QUEENSTOWN LAKES DISTRICT COUNCIL

Hearing of Submissions on Stage 3 Proposed District Plan

Report and Recommendations of Independent Commissioners

**Report 20.9: Arthurs Point North Mapping
Informal Airports**

Location of ONL boundaries as proposed by Arthurs Point Outstanding Natural Landscape Incorporated (Figure 2 of their submission).

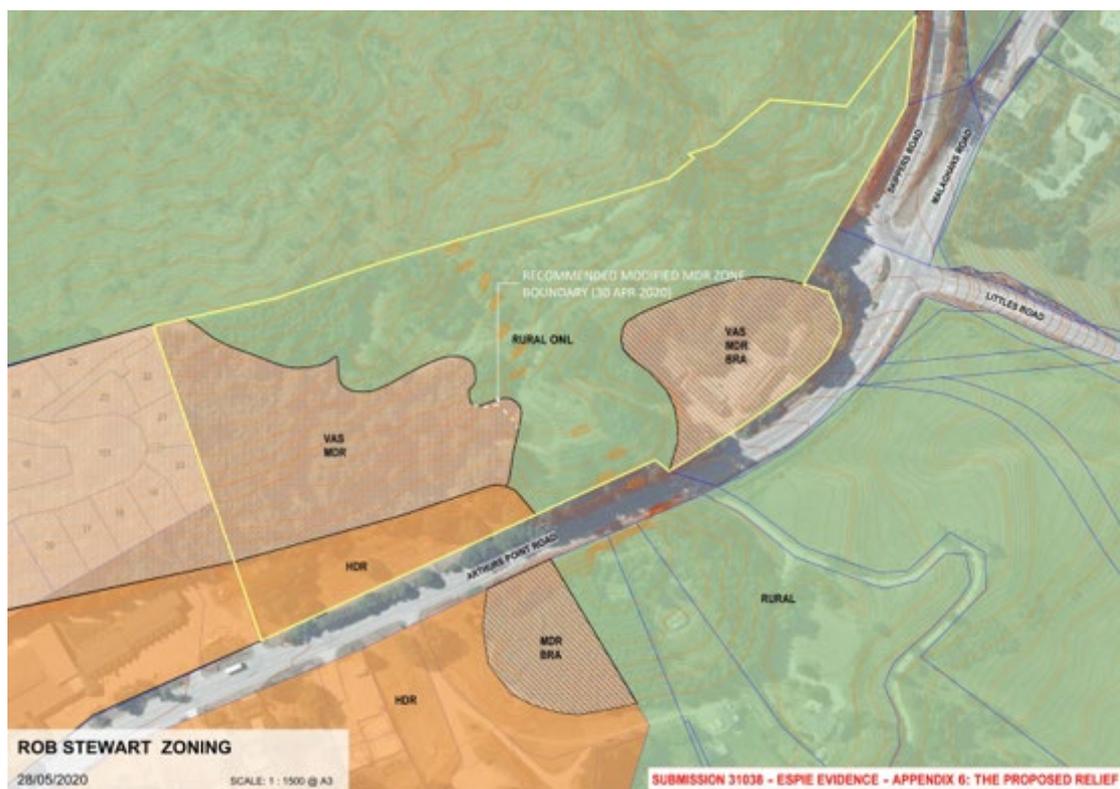
Natural Landscape Society Inc⁵ sought that revised ONL boundaries be defined around the entire Arthurs Point area. Ms Turner considered that submission out of scope insofar as it sought to define ONL boundaries other than around the Arthurs Point North area. Insofar as the Society sought a new boundary on the north side of Arthurs Point North, it appears to largely follow Ms Mellsop's identified high landscape sensitivity boundary, that is to say including the Arthurs Point Woods Property within the ONL.

24. On the south side of Arthurs Point North, the Society's proposed ONL line would exclude an area on the south-east corner of Arthurs Point North with a notified MDRZ zoning.

27. We would therefore at least entertain consideration of ONL lines near Arthurs Point North. However, the scale of the Society's relief, seeking to draw ONL lines around all of the Arthurs Point urban area, clearly stretches far further than the consequential/incidental amendments that Kos J discussed in the *Motor Machinists* decision discussed at length in Report 20.1. Moreover, the Society did not appear before us and produced no evidence to support its submission. It follows in our view that the only place where a substantive change to the ONL boundary might be justified is if we prefer to rely on Ms Mellsop's June 2019 assessment and rejected the pragmatic decision to draw the ONL line around the Arthurs Point Woods property.

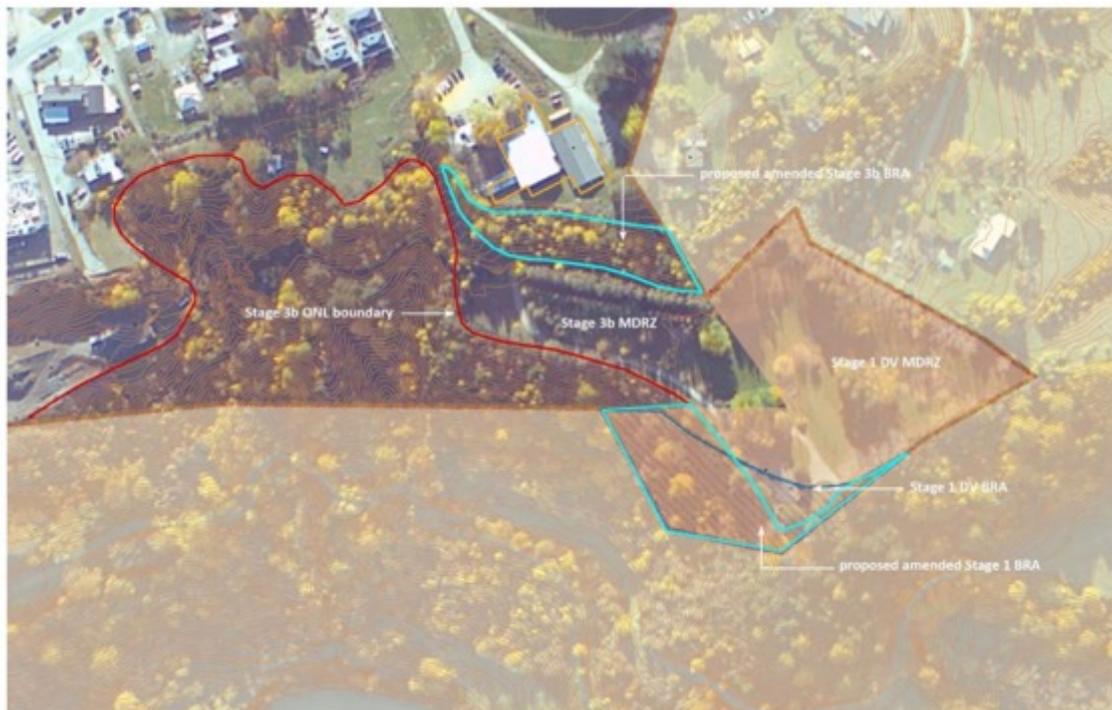
39. It follows that we do not accept Ms Turner's recommendation in this regard. We recommend that the ONL line be positioned on the Stewart property in the location recommended by Ms Mellsop, as shown below.
